West River Manor Unit One

City Plan Commission — April 9, 2026 **REVISED**

CASE NUMBER/TYPE:	SUSU26-00015 – Major Combination
CASE MANAGER:	Myrna Aguilar, (915) 212-1584, AguilarMP@elpasotexas.gov
PROPERTY OWNER:	West River Manor, LLC
REPRESENTATIVE:	Del Rio Engineering, Inc.
LOCATION:	North of Borderland Rd. and East of Strahan Rd. / Extraterritorial Jurisdiction (ETJ)
PROPERTY AREA:	16.85 acres
VESTED RIGHTS STATUS:	Not Vested
PARK FEES:	\$64,390.00
EXCEPTIONS/MODIFICATIONS:	Yes, see following section
ZONING DISTRICT(S):	N/A property lies within ETJ

REQUIRED CROSS-SECTION:

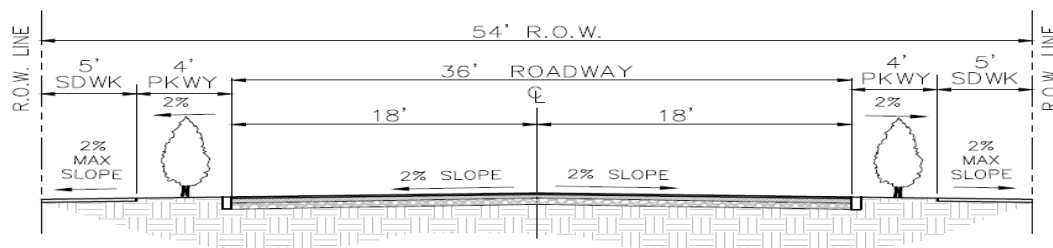
EXCEPTIONS, MODIFICATIONS, OR WAIVER REQUESTS: The applicant is requesting the following exception requests pursuant to El Paso City Code Section 19.48.030 (A) – Criteria for approval of the applicable code. The exceptions include the following:

1. To waive the dedication and construction of 6-feet of additional right of way for all local cross-sections with in the proposed subdivision.

EVALUATION OF EXCEPTION REQUEST: The exception request to waive right-of-way improvements meets the criteria set forth in El Paso City Code 19.48.030(A), which allows for exceptions under special circumstances arising from the physical surroundings, shape, topography, or other features affecting the land, such that the strict application of the code would create an unnecessary hardship or inequity for the applicant. In this case, the requested exception is intended to maintain consistency with adjacent developments and exceeds the minimum roadway design requirements. Additionally, the development is not subject to sidewalk requirements; instead, a minimum 5-foot parkway is required. The proposed 9-foot parkway exceeds this minimum standard and is therefore compliant.
